INDRAPRASTHA GAS LIMITED

TENDER NO. IGL/ET2/CP/CP18492
SUPPLY AND INSTALLATION OF FRP POLE ROUTE MARKERS FOR DELHI & NCR

Replies to Bidders' Queries - 1 dated 29.07.2025

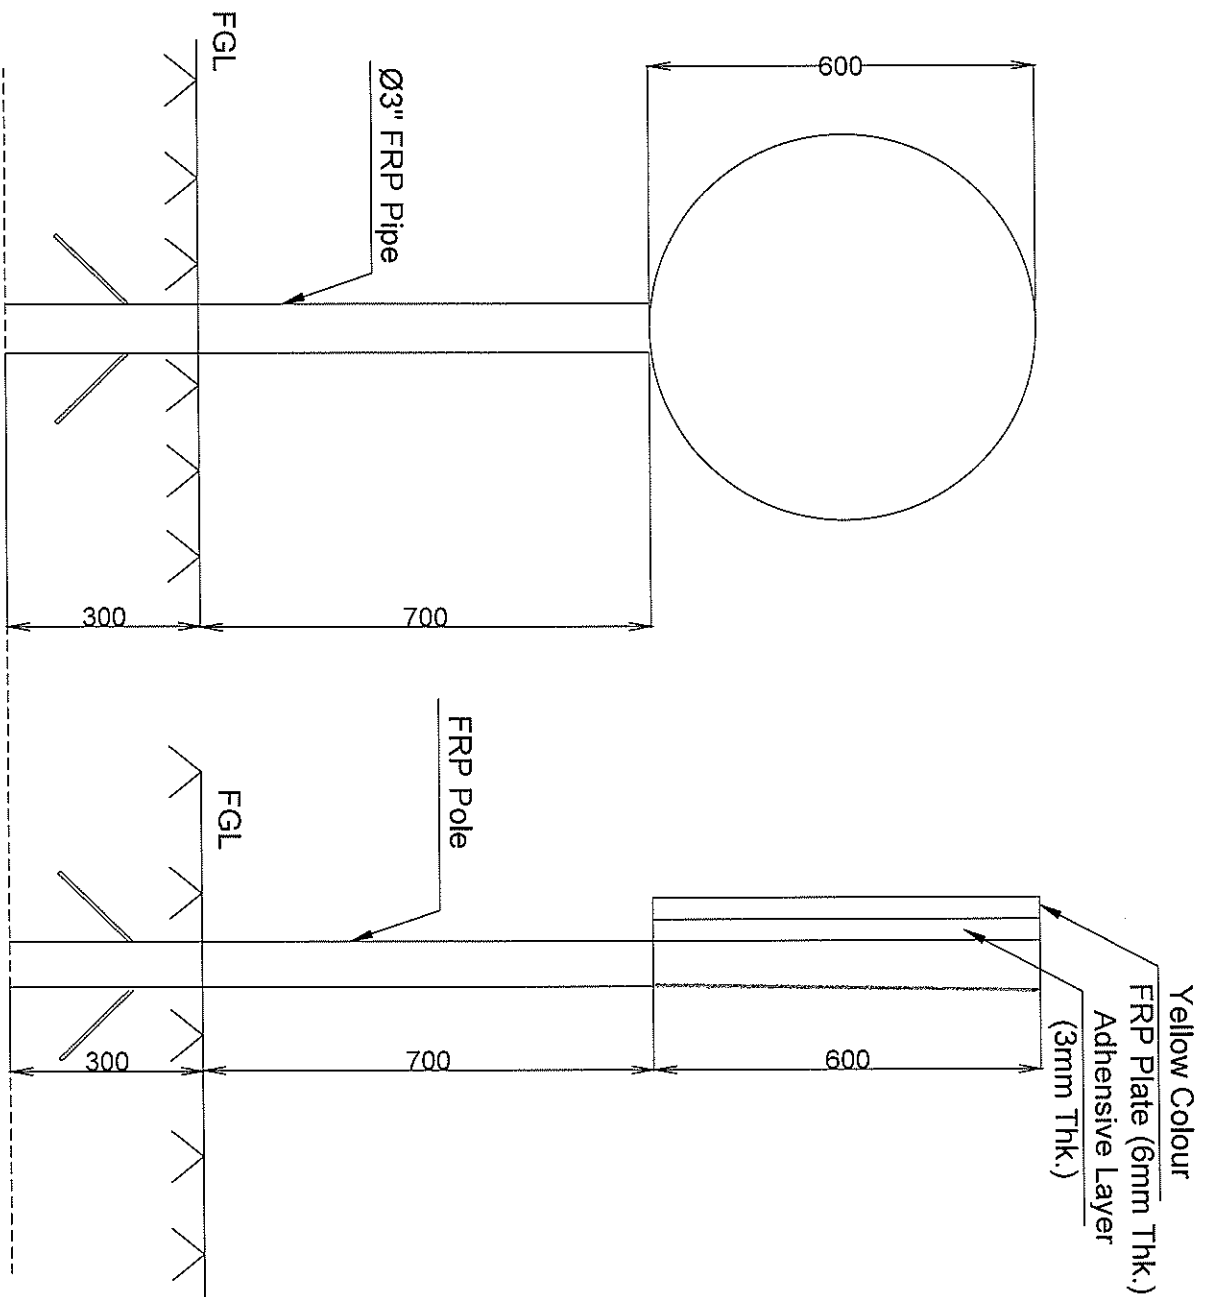
Sr. No.	Page No.	Clause No./ Spec. No.	Description	Bidder's Query	IGL's Reply
1	72 of 97	SOW	-	Marker Sheets: The drawing shows only one marker sheet (600 mm), whereas the scope of work mentions two sheets. Could you kindly confirm if there is an oversight or if additional details are available regarding this?	The bidder's understanding is correct. With reference to the drawing there is only one marker sheet of dia 600mm and thickness 6 mm. (Refer updated drawing).
2			-	Section-V Scope of Work – Point 2(xiv): The description provided in Point 2(xiv) of Section 5 is unclear. We would appreciate further clarification on this section to ensure correct interpretation.	This supersedes points 2(iii), 2(ix) and 2(xiv) in technical specifications for FRP marker under Section-V Scope of Work.
3			-	PVC Sleeve in FRP Pole: The scope of work specifies the use of a PVC sleeve in the FRP pole. We would like to confirm if this is a mandatory requirement	Yes, PVC sleeve is a mandatory requirement.
